SUBJECT: Forwards partial response to EG Tourigny 870716 request for addl info re 870612 application for amend to license. Util will respond to certain portions of request in near future. Phased response acceptable by NRC.  
*See @ DRAWINGS*

L-87-374

Re: St. Lucie Unit I  
Docket No. 50-335  
Spent Fuel Rerack

FIGURE 1

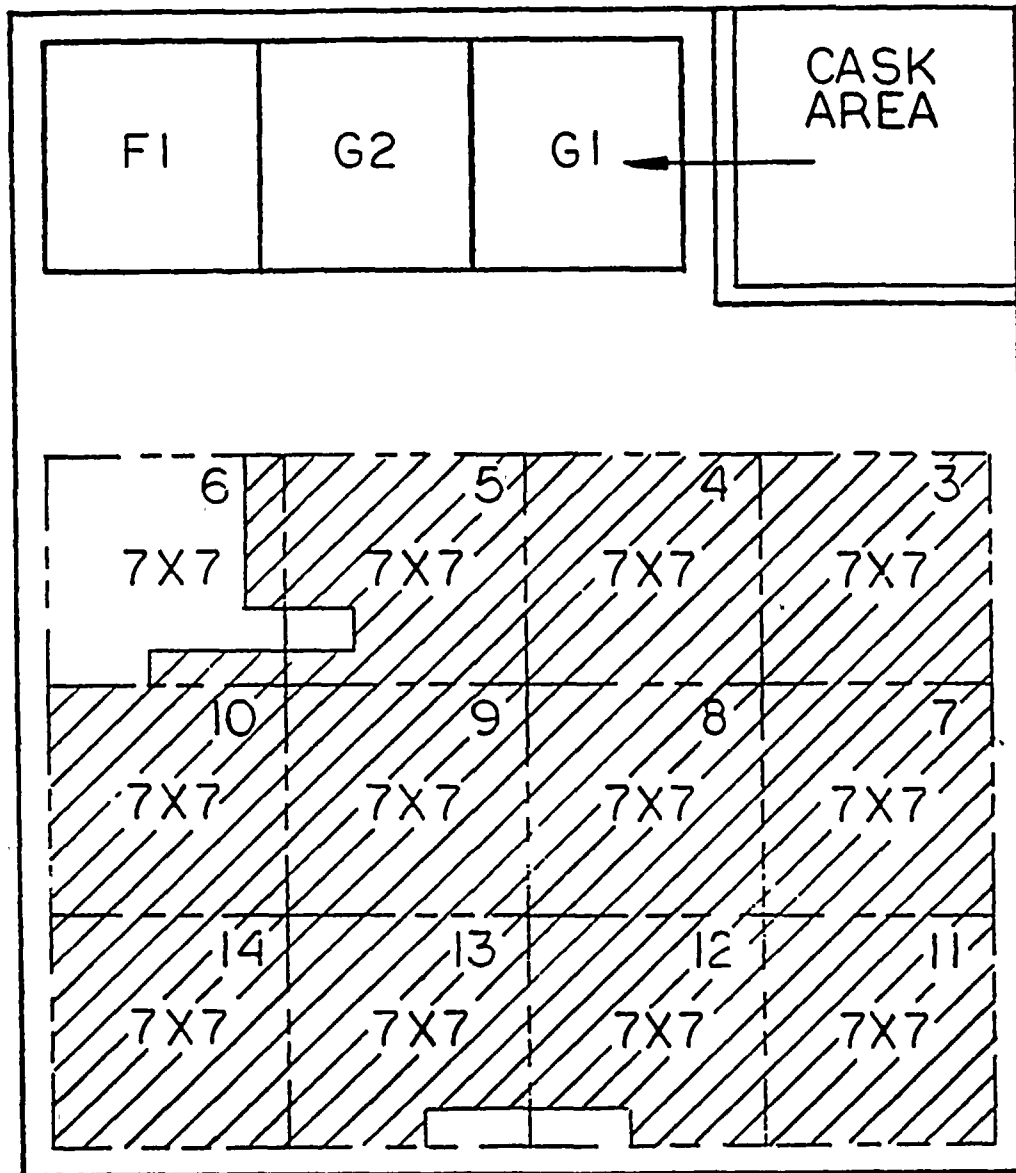
QUESTION: For each step in the replacement of the racks, provide drawings which show the location of the spent fuel and the movement of the fuel which demonstrates that no heavy load will be carried over spent fuel or over any rack which contains spent fuel. (Note: This information can be placed on the set of drawings provided in response to question 5).

1. Following the removal plan (see question #5), remove Racks 1 and 2 from the pool as shown in Figure #1.
2. Following the installation plan (see question #5), install Racks F1-G2-G1 as shown in Figure #2.

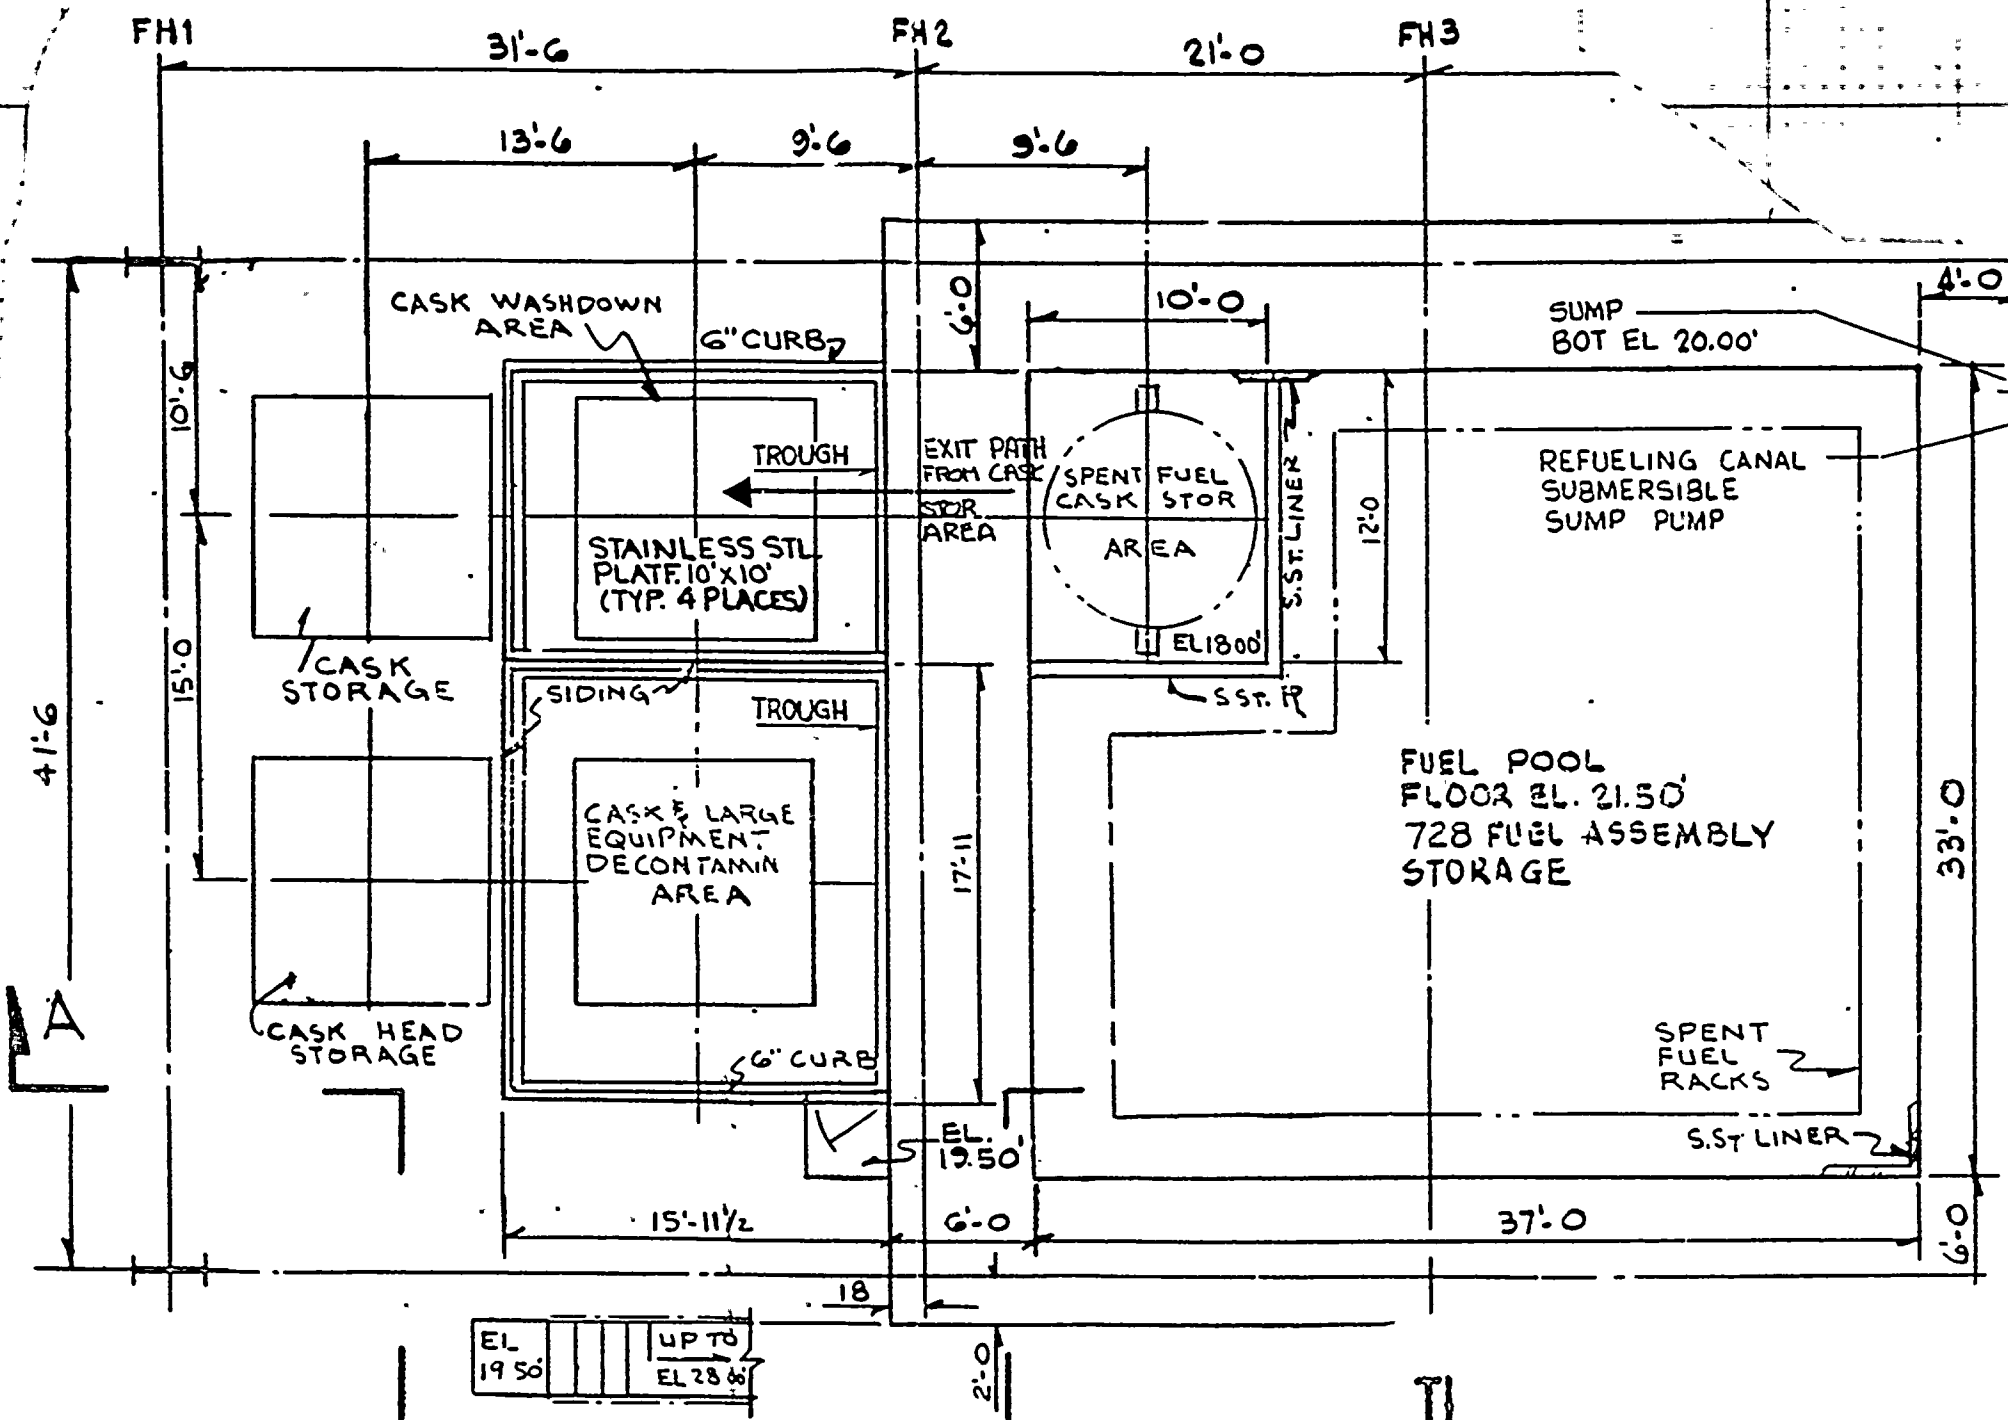
QUESTION: Provide drawings which show the movement of both the existing and the new racks throughout their entire path of travel from outside of the fuel handling building until their final location in the spent fuel pool (and the reverse for the existing racks).

RESPONSE: For the removal of the racks from the spent fuel pool cask storage area to outside the spent fuel pool (see General Arrangement sketch SK-83-02-M-001 attached) each rack module will be removed individually following a path that does not carry the rack over any other racks containing spent fuel (see response to question number 6). Each rack module will be removed by crane and transported over a prescribed path to the spent fuel cask storage area. The old racks will be washed down and dried. The dried racks will then be placed in polyethylene bags and removed to the cask equipment decontamination area. The polyethylene bags will be removed and discarded and the racks will be cleaned until desired results are achieved. The racks will be inserted in clean polyethylene bags and moved to a designated rack storage area on site.

For installation of the new spent fuel racks the racks will be brought from their onsite storage location to the cask washdown area and cleaned as required. After cleaning is complete each rack module will be transported into the spent fuel cask storage area. From the spent fuel cask storage area the module will be transported over the spent fuel pool (see response to number 6) to its proper location, where it will be placed. During the process the racks will not be carried over racks containing spent fuel.
